SA-07-001-2015
Bridge #7 Route 9
Town of Bennington
Barney Brook

01/07/15
Josh Carvajal

Profile View (N.T.S.)

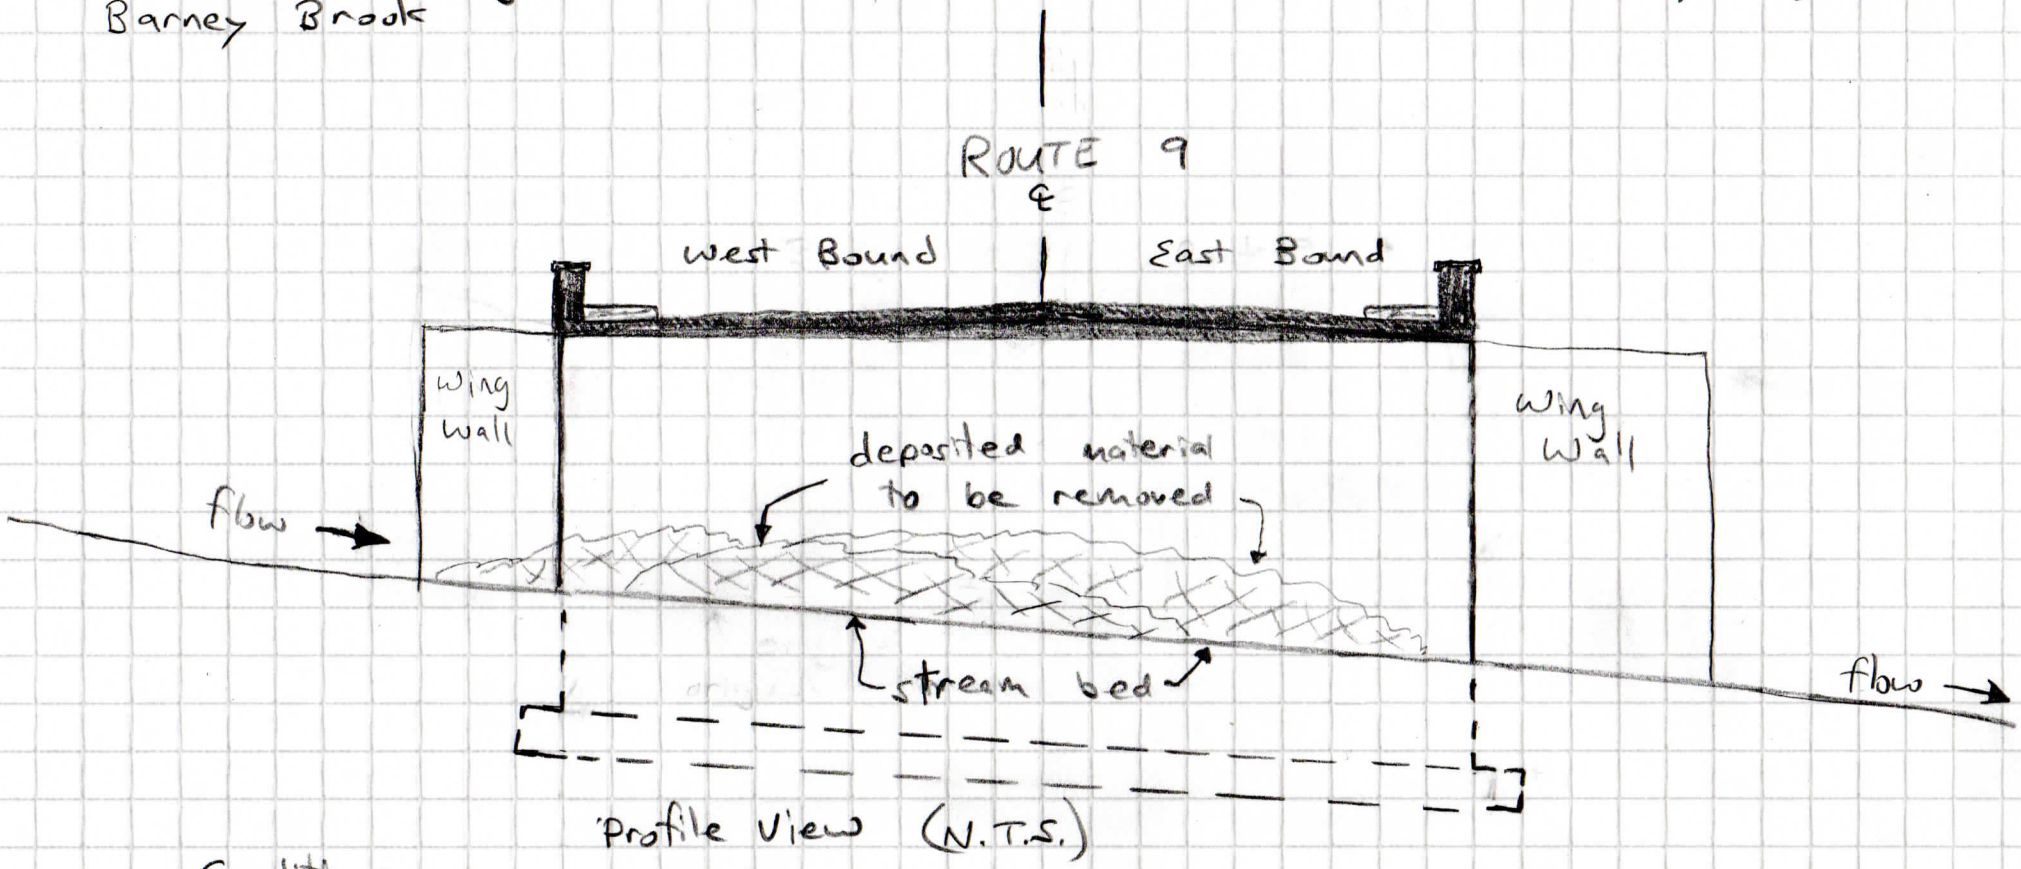
- Bypassing of stream flows is required to ensure materials being excavated are isolated from flowing water
- Final bed slope under bridge should match upstream and downstream elevations to maintain a constant stream slope
- Sandbagging to redirect stream flow away from work area is acceptable for minimizing impacts to VT Water Quality Standards
